**HILLSBOROUGH COUNTY
SOUTHEAST COUNTY LANDFILL
CAPACITY EXPANSION, SECTION 8
CERTIFICATION OF CONSTRUCTION
COMPLETION REPORT
RESPONSE TO DEP REQUEST FOR
ADDITIONAL INFORMATION**

Subject: Response to Request for Additional Information
Southeast County Landfill, Hillsborough County
Capacity Expansion Section 8
Certification of Construction Completion
Permit No. 35453-009-SC
Jones Edmunds Project No. 08449-020-01

**HILLSBOROUGH COUNTY
SOUTHEAST COUNTY LANDFILL
CAPACITY EXPANSION, SECTION 8 CLASS I LANDFILL
CERTIFICATION OF CONSTRUCTION COMPLETION REPORT
RESPONSE TO DEP RAI**

ATTACHMENT R8
SIGNED AND SEALED FINAL AS-BUILT SURVEY

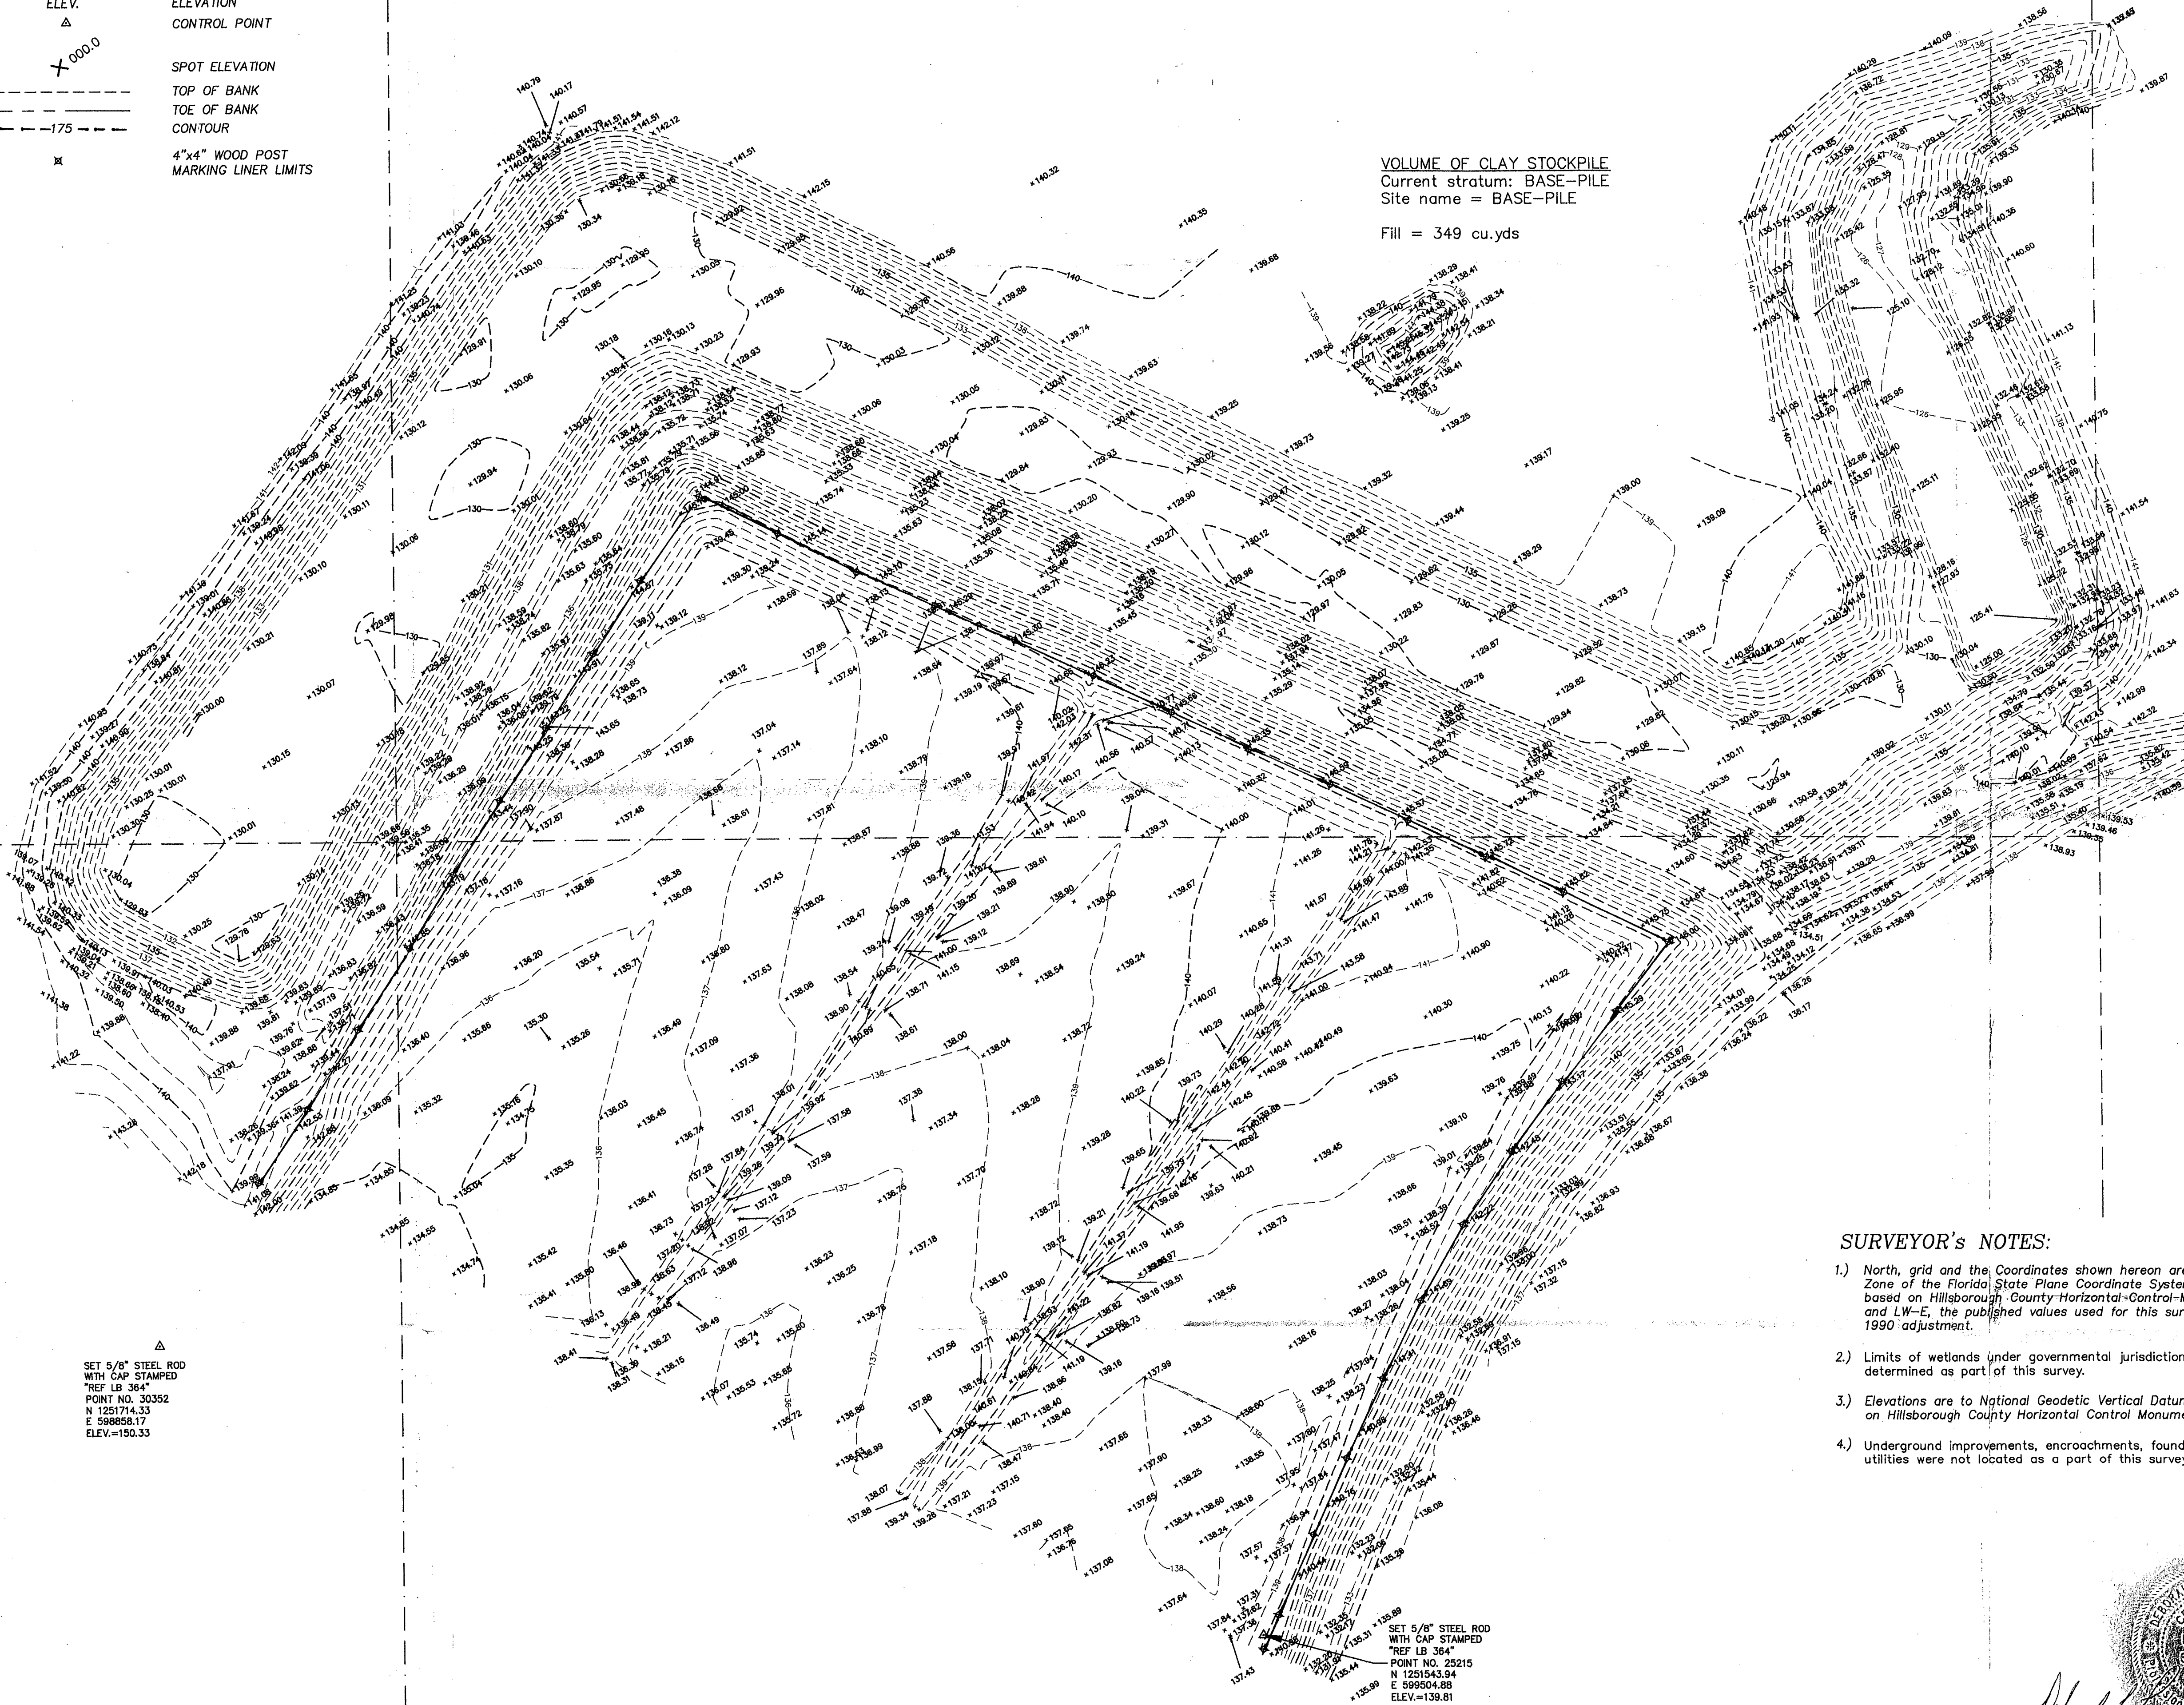
Comment 8: Section 10, Final survey. Please provide a signed and sealed as-built final survey. See also Comment #5.b. above.

Response 8: A signed and sealed as-built final survey is provided in Attachment R8. An outline of the disposal cell is included on the as-built final survey. See Response 5.b regarding verification of the thickness of the clay subbase, protective cover soil, and tire chip layers.

Figure 1. CLAY TEST LOCATIONS, SOUTHEAST COUNTY LANDFILL, HILLSBOROUGH COUNTY, FLORIDA

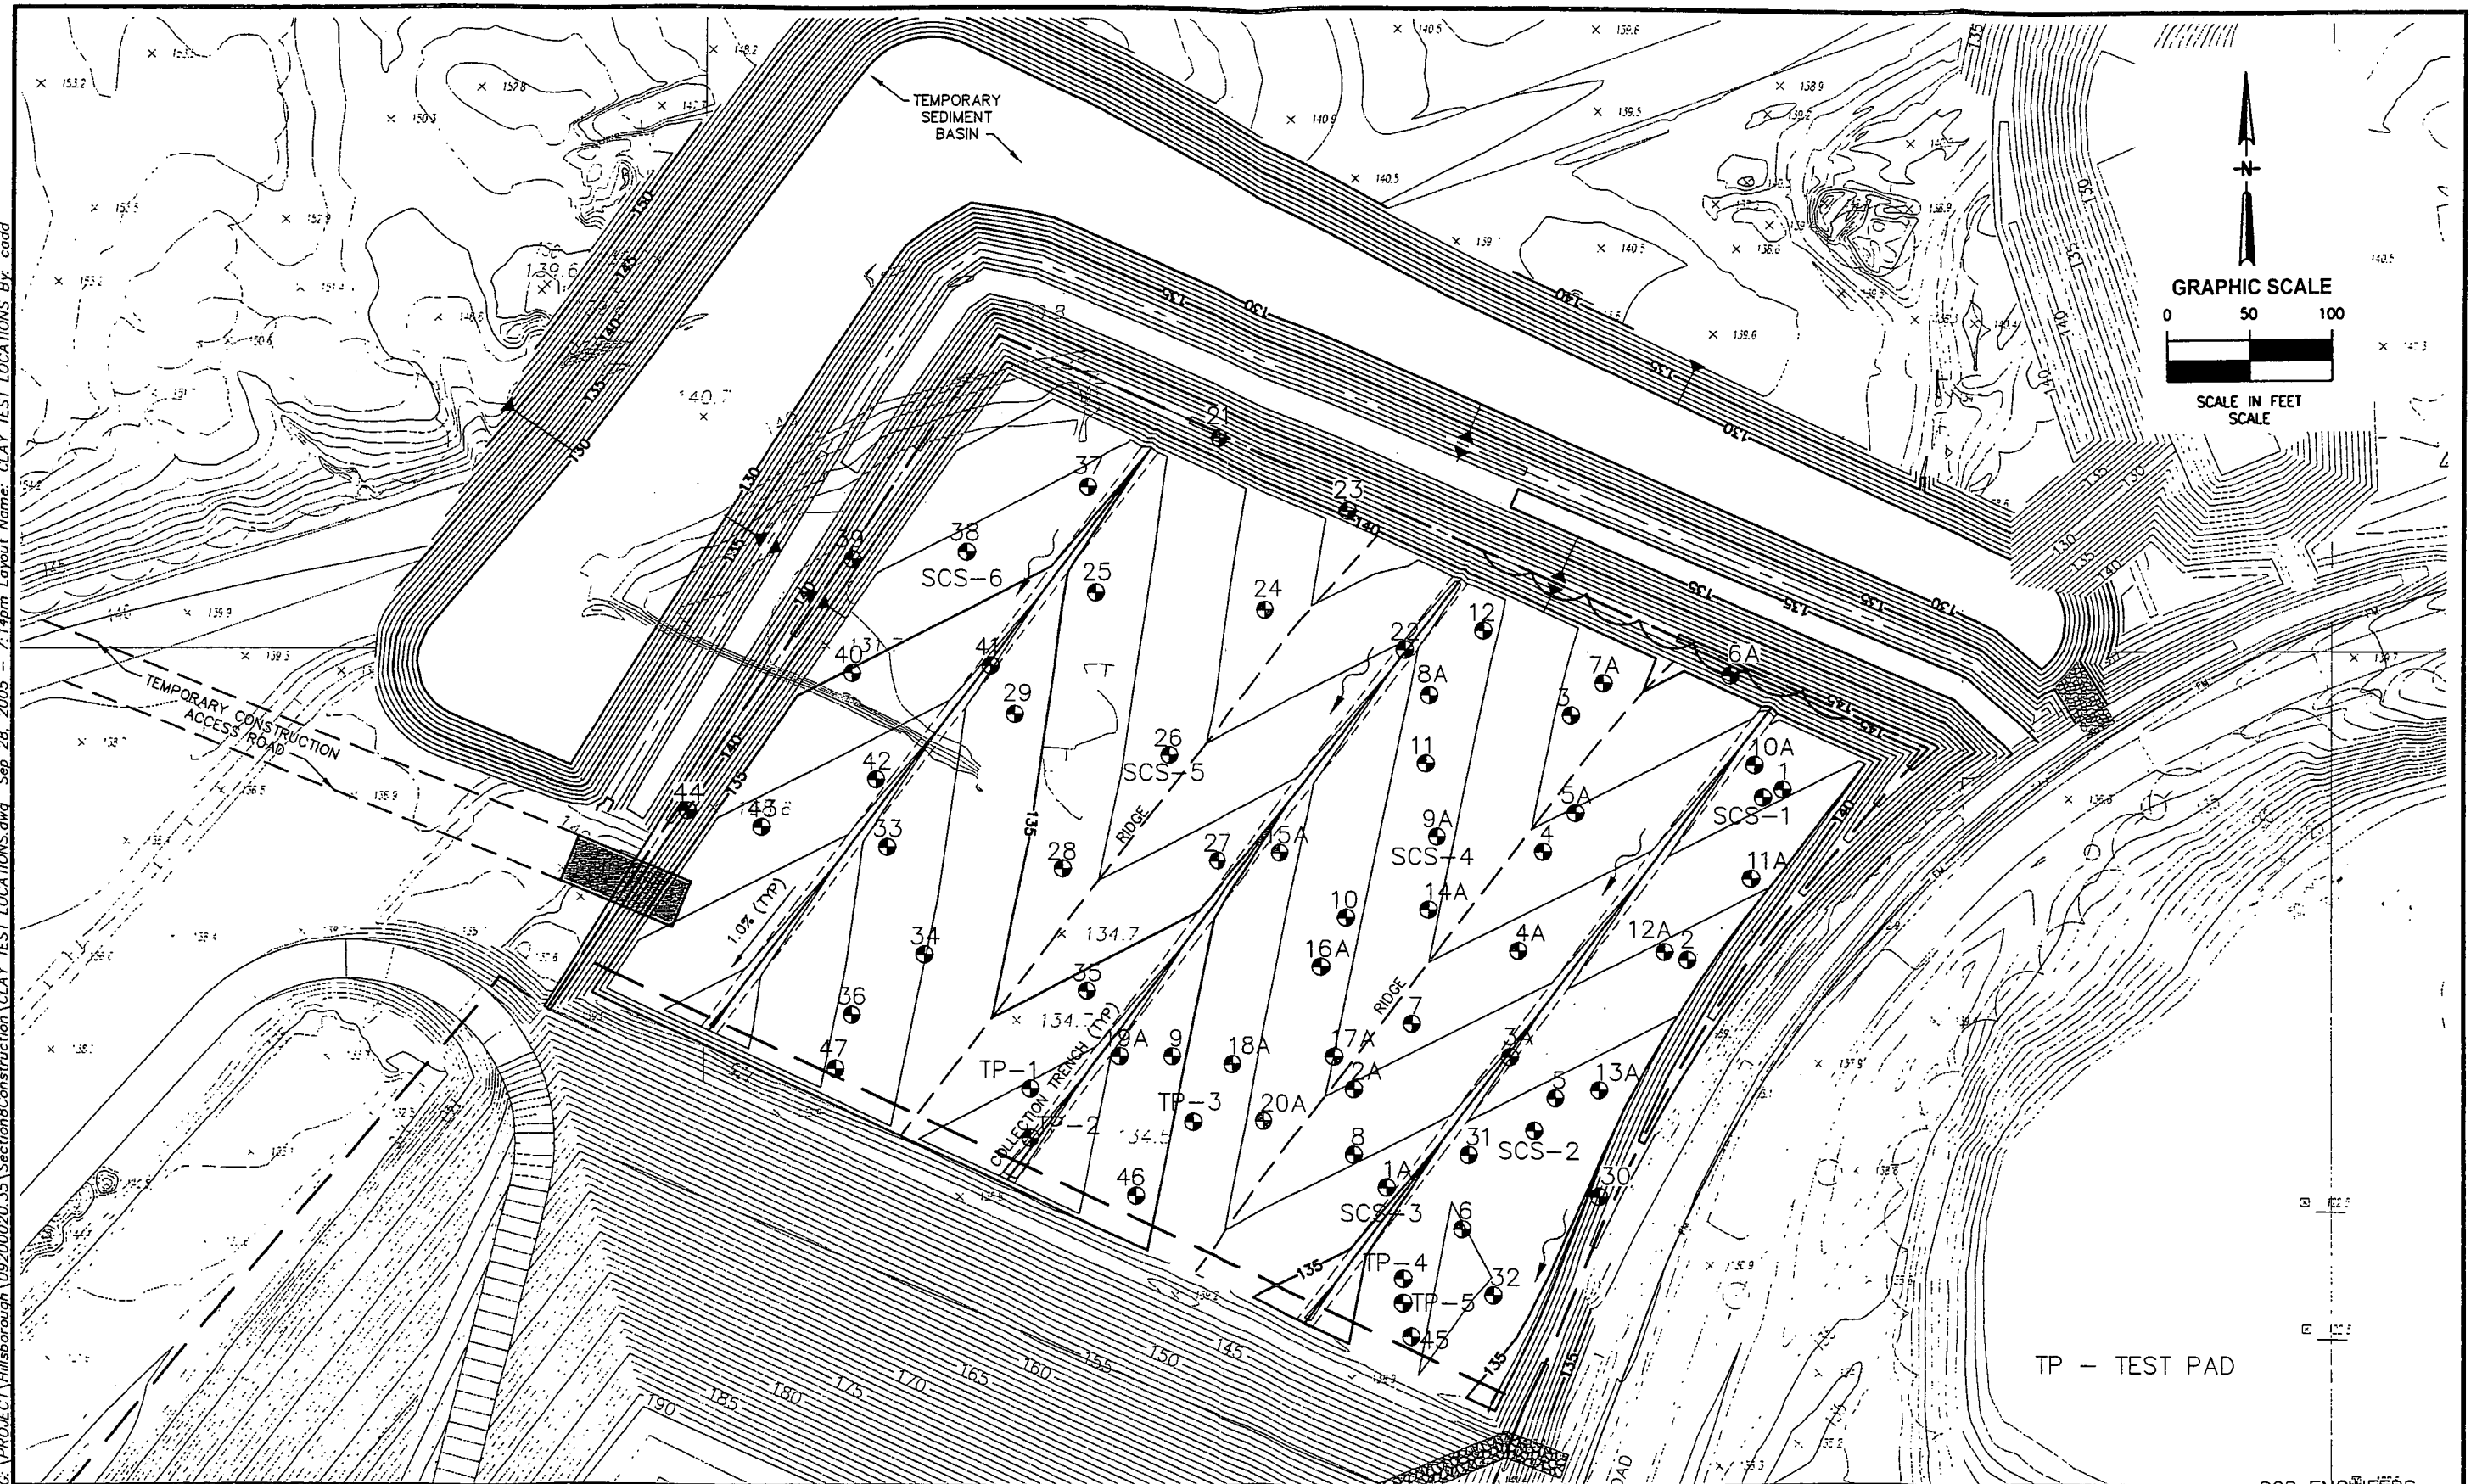
- 1) *Please provide a table or list of test results that correlate with those shown on Figure 1. Please include a north arrow and scale on Figure 1.*

- 1) *Test strip. Please show the locations of samples P1, P2 and P3 on Figure 1 (Attachment 5-3). Please show the location of the test pad on Figure 1 (Attachment 5-3). Since Qore is the soil CQA contractor, please explain why Qore appears to have been contracted by Burcaw to conduct permeability tests.*

Response 18.c.1): In the CQA test results performed by PSI and as shown in Attachment 5-3, PSI sample Test #1 correlates to SCS -1 as shown on Figure 1, Test #2 correlates to SCS-2 on Figure 1, etc. Therefore, a table is not warranted. Figure 1 has been revised to include a north arrow and scale (Attachment R18.c.1).

Response 18.d.1): The locations of samples P1, P2, and P3 are shown in Figure 1 as TP-1, TP-2, and TP-3 (TP = Test Pad). The location of the 200-foot-by-50-foot test pad was located in the southeast corner of the Section 8 cell (see sample locations TP-1 through TP-6). Burcaw used Qore as a subcontractor for the permeability tests. Burcaw did not have the resources to perform the flexible wall permeability tests.
